Service Letter No. 411

SUBJECT: Drain Holes in PA-30 Cowling

MODELS AFFECTED: PA-30 Twin Comanches, Serials 30-1 to 30-85 inclusive

SKETCH 2

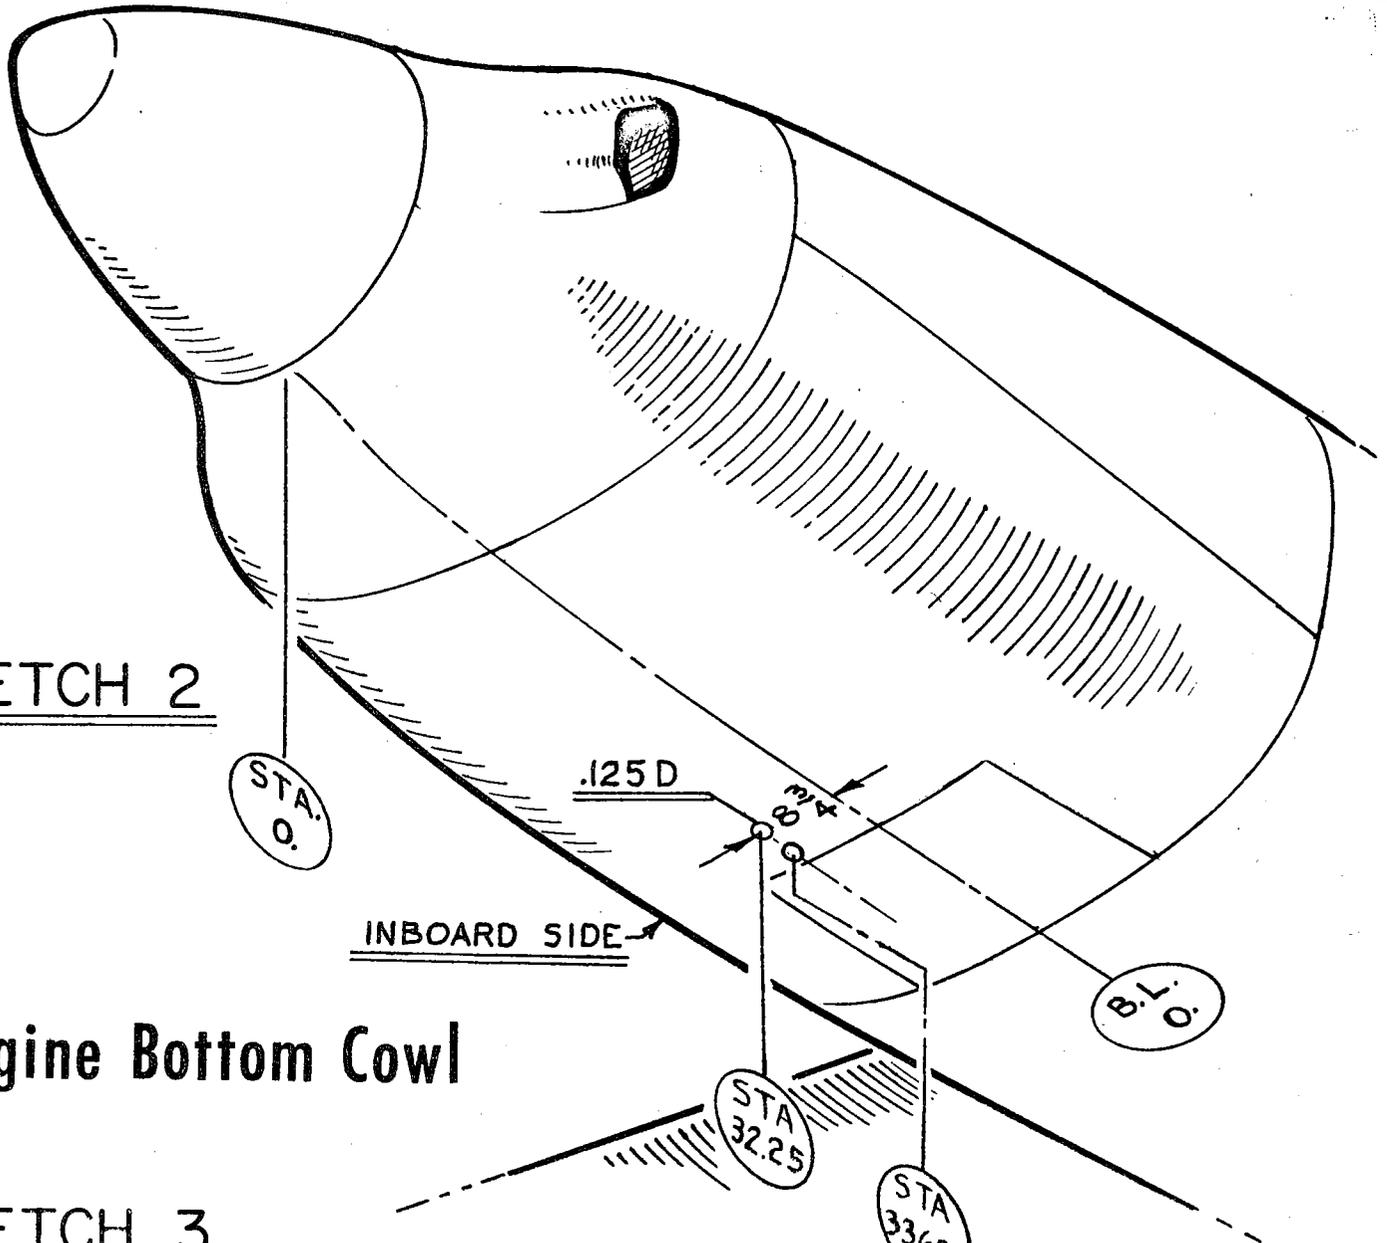
1. Add a .125 drain hole at Station 11.125 and B.L.O. in bottom of fiberglass nose cone, part number 23755-00.
2. Add two .125 drain holes in bottom of each engine bottom cowl, part number 23867-05, right, and part number 23867-06, left, at Stations 32.25 and 33.687, 8-3/4" inboard from the cowl centerline.
3. Add a .125 drain hole in each air filter box assembly, part number 23883-00, per sketch attached to this letter.

SKETCH 3

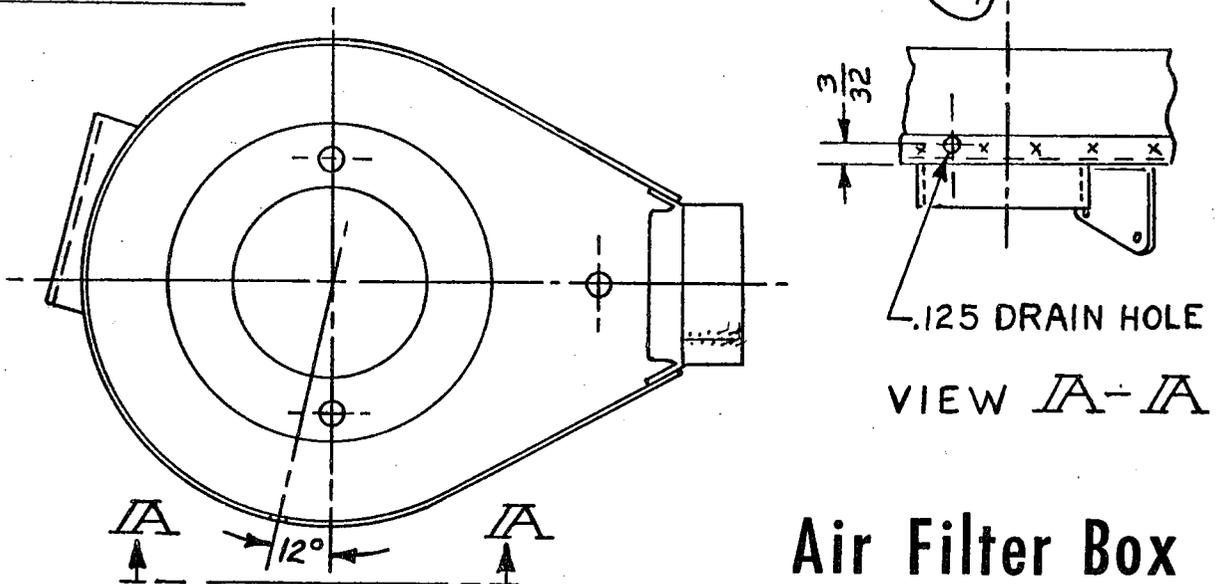
Be sure aluminum chips that result from drilling are completely removed from the air filter boxes.
